INDESIT company

Model type:
WAT10IT

Commercial code:
F028314

FIG. 1

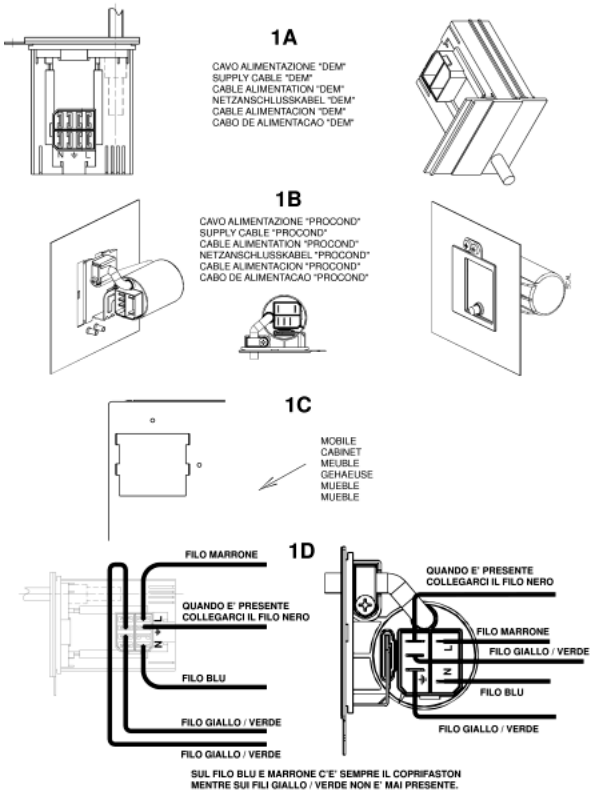
To use premodified wirings on modified products perform the connection to the terminal block of the new cable as shown in fig. 1 - 1D.
The wiring diagrams indicated in the Documentation remain the same.

N1040309FIG1

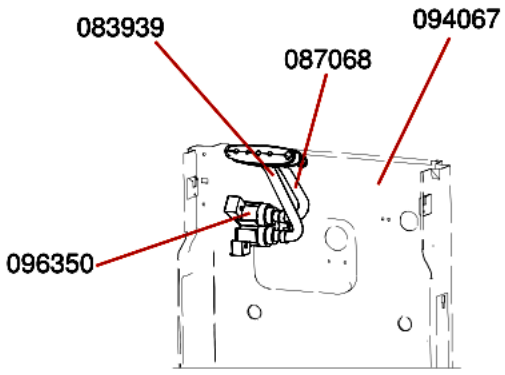
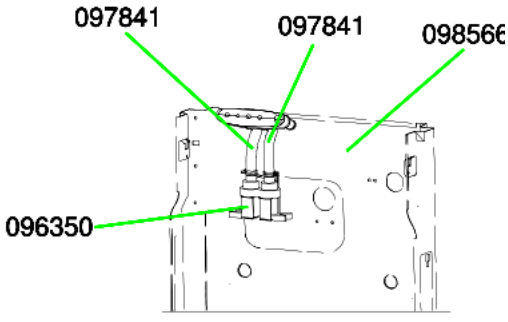
From serial no. 30912.0001, the system used for fixing the loading solenoid valve (spare part code 096350) to the rear panel has been modified on Top Loading washing machines, rotating its position by 90°.
The solenoid valve (spare part code 096350) has been modified with the 45° rotation of a coil; the Replacements Warehouse will continue to manage this part with the same code. When replacing on premodification machines, fit the coils as shown in figure N1040309FIG3-1 and on modified machines, as shown in figure N1040309FIG3-2; to rotate the coil, lift it using a screwdriver and then refit according to the inserts on the plastic.

Replacement codes of the parts affected by this modification (see figure N1040309FIG1):

FIG1 A - PREMODIFICATION STRUCTURE
solenoid valve tube/distributor assembly: premodification 083939;
solenoid valve tube/distributor assembly: premodification 087068;
rear panel: premodification 094067.
FIG1 B - NEW STRUCTURE
solenoid valve tube/distributor assembly: new 097841;
solenoid valve tube/distributor assembly: new 097841;
rear panel: new 098566.

Premodification panels will be managed by the Replacements Warehouse while stocks last; when replacing with new ones on premodification appliances the new tubes must also also be used.
When using the new panels on appliances before serial no. 30609.0001, fitted with solenoid valve code 083940, rotate the coil 45° and follow the instructions given above for code 096350, paying attention during the wiring phase to keep the cables away from the bowl support spring.

N1040309FIG2

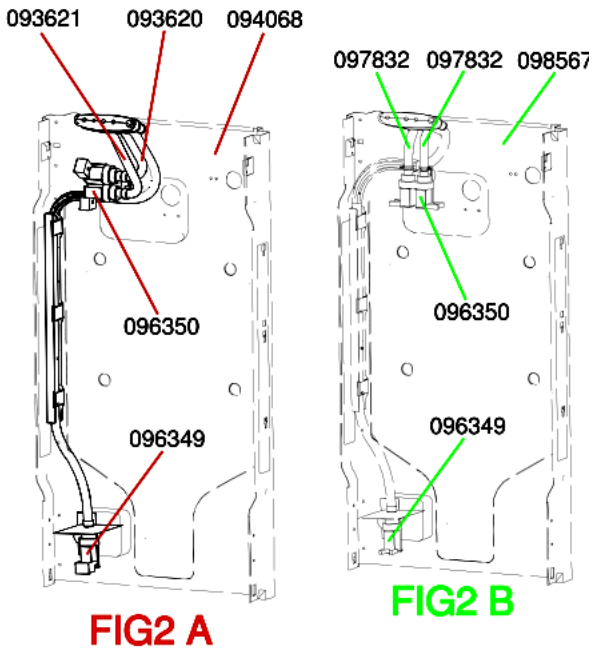
Replacement codes of the parts affected by the modification to WMTL80UK (see figure N1040309FIG2):

FIG2 A - PREMODIFICATION STRUCTURE
solenoid valve tube/distributor assembly: premodification 093620;
solenoid valve tube/distributor assembly: premodification 093621;
rear panel: premodification 094068.
FIG2 B - NEW STRUCTURE
solenoid valve tube/distributor assembly: new 097832;
solenoid valve tube/distributor assembly: new 097832;
rear panel: new 098567.

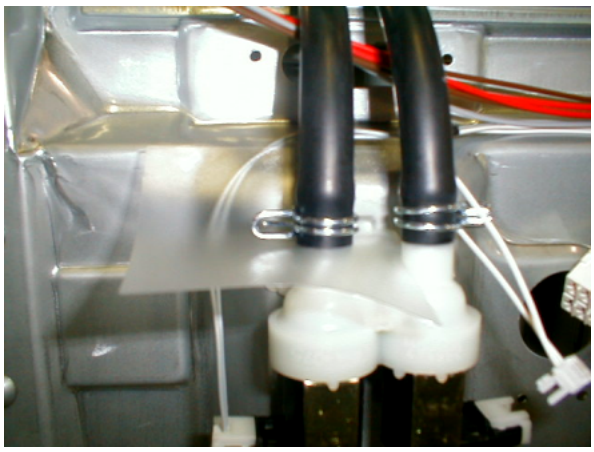
n1040321: Plastic protecion for solenoid valve.

All top-load washing machines produced from September 2003 to February 2004 (from serial no. 30900.0000 to 40300.0000) have been equipped with a plastic protection Service code 109798 (shown in N1040321FIG1), to prevent water from damaging the solenoid valve and electronic card.

N1040324FIG1

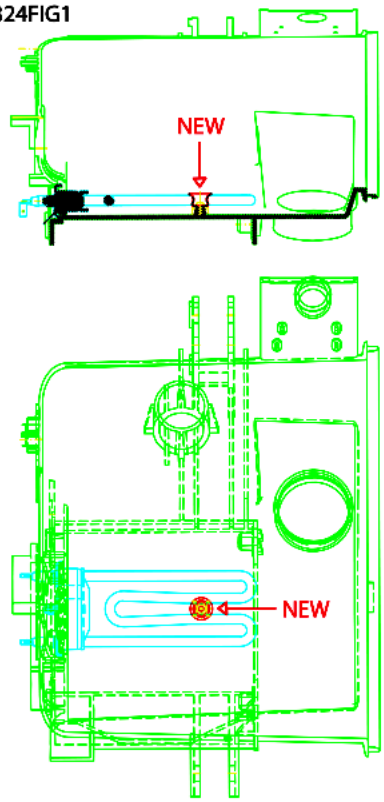
From serial number 40506.0001, the fixing system of the heater to the tank has been modified on all top-load washing machines affected by this note, with the introduction of a metal retainer (image N1040322FIG1 reference NEW) in place of deflector Service code 055322.

The modification has involved both heater and tanks. Given below are the Service codes of the new and old items concerned:

-PLASTIC TANK FOR 600-1000 RPM MACHINES: new 110152, premodification 083805;

-PLASTIC TANK FOR 1200 RPM MACHINES: new 110153, premodification 092023;

-HEATER: new 110148, premodification 083906.

N1040404FIG1

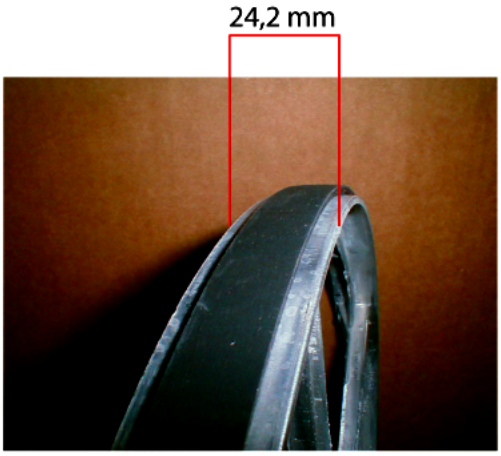
n1040404: New pulley installed on top loading washing machines up to 1000RPM (NO tub lock)

From serial no. 51202.0001 the pulley track has been widened from 21.2mm to 24.2mm (see picture N1040404FIG1).

new pulley
C00142832 - D280 24.2 mm track

Premodification pulley
C00083912 - D280 21.2 mm track

The new pulley can also be used on premodification versions of the models referred to in this release.
